MONTGOMERY COUNTY HISTORIC PRESERVATION COMMISSION
STAFF REPORT

Address:	4721 Essex Ave., Chevy Chase	Meeting Date:	10/11/2017
Resource:	Primary (Pre-1915) Resource (Somerset Historic District)	Report Date:	10/4/2017
Applicant:	Richard and Michelle Scurfield	Public Notice:	9/27/2017
		Tax Credit:	N/A
Review:	HAWP	Staff:	Michael Kyne
Case Number:	35/36-17I

PROPOSAL: Rear addition, garage, hardscape, and tree removal

Staff recommends that the HPC **approve with conditions** the HAWP application.

Right Elevation - Proposed
3/32" = 1'-0"

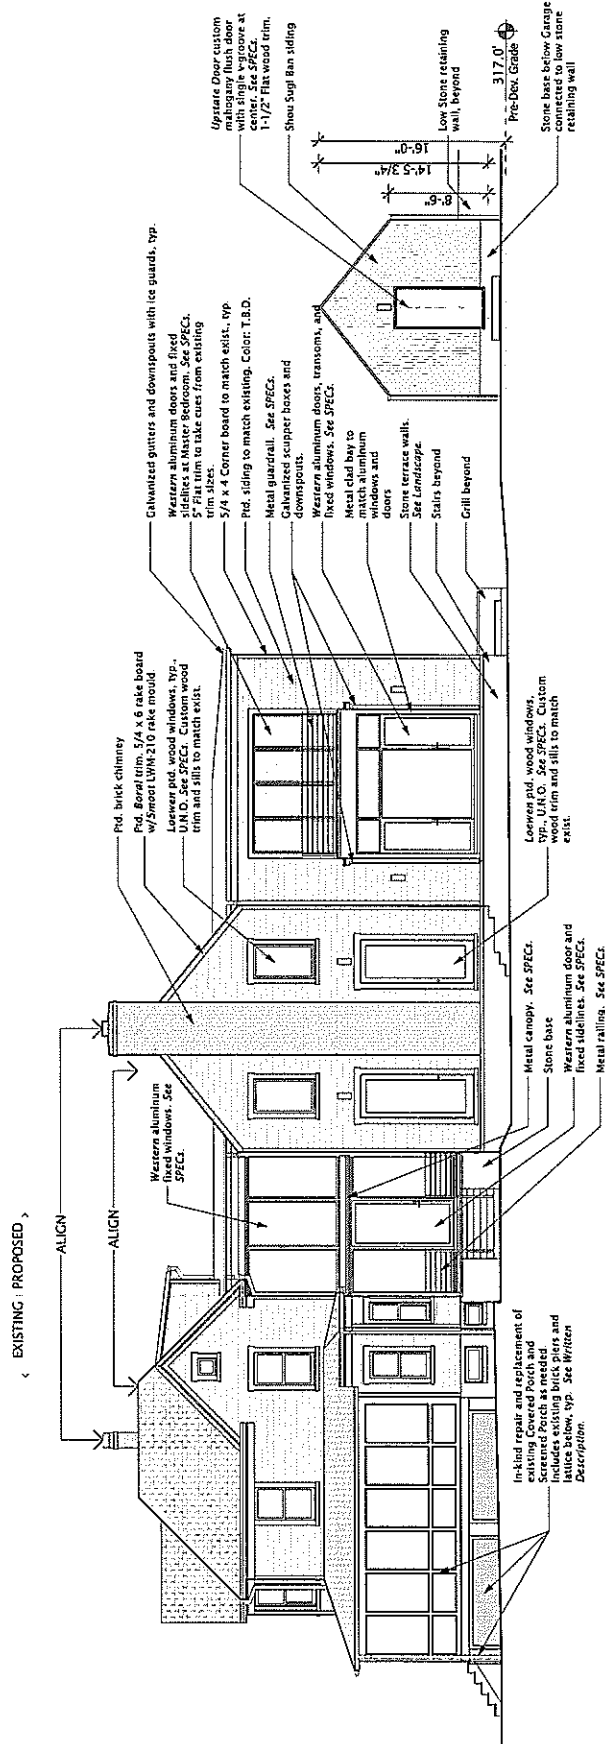
Staff notes that, although the written description of the project indicates that the proposed replacement fence at the right side of the historic house will be 4' tall, the submitted plans indicate that the fence will be 4'-6" (see Circle 45). Because the fence is forward of the rear plane of the historic massing, staff suggests a condition of approval, stipulating that the proposed replacement fence will not exceed 4' in height, which is consistent with the Commission's typical requirements.

1. **Specifications for the proposed standing seam metal roof and any associated features (i.e., ridge caps, vents, snow guards) will be submitted, with final review and approval delegated to staff.**
2. **The proposed replacement fence at the right side of the historic house will not exceed 4' in height.**
